Access Compliance Report

Public Rights-of-Way

Main Street: **ST_CLOUD_DR** Cross Street: **SEAL_BEACH_BLVD** Location: **NW**

ADA ID: **SGRK211206162027** Signal Type: **One Push Button-Non APS** Overall Compliance: **No** Severity Scores: **BTN 1: 35** **BTN 2: N/A** **No BTN: N/A**

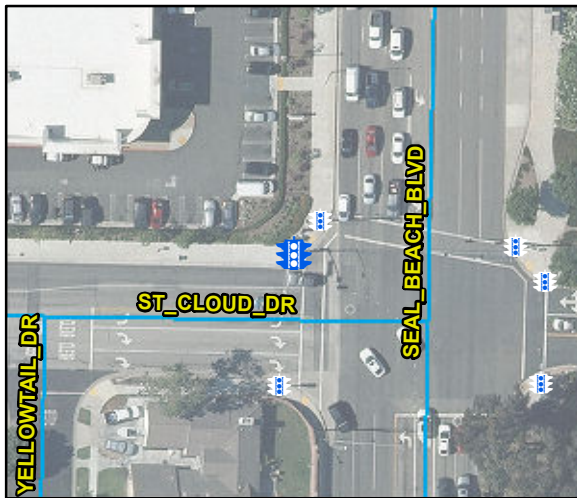
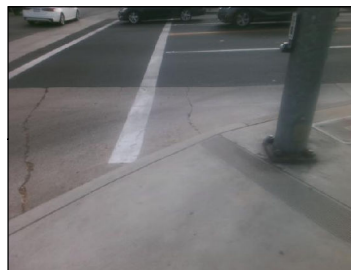
OC Std/PROW: MUTCD 4e.08, R404.2

Yes	B 1 Diameter (in)	2	N/A	B 2 Diameter (in)	N/A
N/A	B 1 Crossing Direction	S	N/A	B 2 Crossing Direction	N/A
No	B 1 DistanceTo XWalk (in)	70	N/A	B 2 DistanceTo XWalk (in)	N/A
Yes	B 1 DistanceTo Curb (in)	33	N/A	B 2 DistanceTo Curb (in)	N/A
	Parcel Identification Number	086-492-90			
	Google Street View Link				
	http://www.google.com/maps/@?api=1&map_action=pano&viewpoint=33.78044963,-118.07222347

Possible Solutions: Replace Signal Push Button With APS Button. Remove & Relocate Sign.
